# The Future of Tillary and Adams Streets Public Meeting #2 Summary

Tuesday, June 23, 2009 6:30 – 8:00 PM

Figure 1 Brooklyn Bridge Gateway Conceptual Design

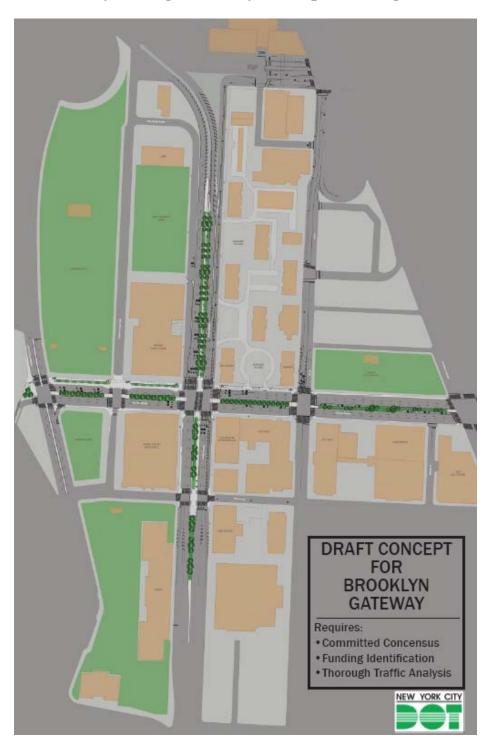
- Indicating southbound approach to Tillary/Adams "Capacity Inadequate"
- Indicating Adams median north of Tillary Street (Brooklyn Bridge Promenade) "Where is capacity to come from to widen median?"

- "Need sufficient turning radius" at Tillary Street entrance to Concord Village
- Does not address diversion of NB service road /Brooklyn Bridge to avoid entering same road

- Re: Partial elimination of divider between main roadway of NB Adams and service road: You plan to create a <u>short</u>, third BB-bound lane. Within a relatively short distance, three lanes are reduced to one lane (at 175 Adams), which is particularly problematic during morning rush hours.

- Left turn off Bridge might not provide enough lanes going straight
- Might be backlogged traffic onto Bridge b/c one lane
- Re proposed changes on SB Adams service road along the federal courthouse: In late afternoon, traffic on SB Adams begins to back up onto the Brooklyn Bridge. As soon as the federal agent, who controls the SB Adams service road at the "mid-block" curb cut leaves between 4:30-5 p.m., SB motorists routinely use the service road as an alternate lane, which acts as a relief valve, primarily for "through traffic." I have observed side-swipe accidents when a SB motorist turns from the main roadway into WB Tillary while a SB motorist on the SB service road proceeds across Tillary.

You propose to reduce the width of the SB service road to one lane, which will allow only turns into WB Tillary because of the extended Tillary median. If this is approved by the federal government and even if the service road were to remain available to the public "after hours," it could no longer serve as a relief lane for "through traffic." The brief length of the newly created straight/turning lane will provide space for only a few cars and queuing traffic will be even longer than it is now during late afternoon/evening rush hours.

Indicating reconfigured northbound Adams Street north of Tillary Street:
 "Concerned – loss of bridge-side parking"; "potential – drivers treat it like a highway"

• Indicating northbound left turn for cyclists at Jay Street and Tillary Street – "how to bikes get to path?"

- Plan Refinements
- General comment "seating in medians?"
- Indicating Adams/Tillary intersection "Placement of traffic lights to keep cars off crosswalk?""

- General comment "Use green materials for everything"
- Indicating Adams Street north of Tillary "Remove all parking along strip in front of Concord Village; more green space, etc"; "here, here. Eliminate parkingokay!"

- "Continue bike path to Navy Street bike lane"
- "Facilitate (northbound left) turn (for cyclists) at Jay Street and Tillary Street
- Indicating northwest corner of Tillary and Flatbush "curb extension"; "bus bulb"

- Indicating median/pedestrian refuge of west side of Tillary/Flatbush "bring further out" (i.e., move east into intersection)
- Indicating southwest corner of Tillary and Flatbush "as big of a curb extension as possible"

- Indicating west crosswalk of Tillary and Flatbush "LPI needed and designated car turn lane"(?)
- Indicating Tillary and Jay "LPI at this intersection would be great"

- Indicating Tillary Street east of Jay Street "take as many lanes of traffic away as possible"
- Indicating northeast corner of Flatbush and Tillary "Curb Extension here cars make right turn and sidewalk is small

- "Add curb extension "at Tillary and Gold Street, southwest and southeast corners.
- Lower "greenery" at intersections to increase visibility for everyone

- Indicating protected curb lane on north side of Tillary between Adams Street and Cadman Plaza east "should be a drop-off/loading zone"
- Indicating buffered class 2 bike lane Adams Street service road north of Tillary Street "bike lane should be buffered or protected. That's a busy road for a class 3 lane" (Note: commenter may have misread this to be a Class 3 rather than Class 2 bike facility)

- Indicating southbound left turns at Adams and Tillary "make sure this phase is exclusive"
- Please work to eliminate permit parking and bike lane parking

- Re Tillary between Adams and Jay In view of the existing bus stop in front of
  the grocery store (270 Jay) and the need for deliveries to the store, the creation of
  a bicycle lane adjacent to the existing sidewalk and addition of a narrow curbed
  sidewalk to protect this bicycle lane from the westbound traffic lanes should be
  revisited.
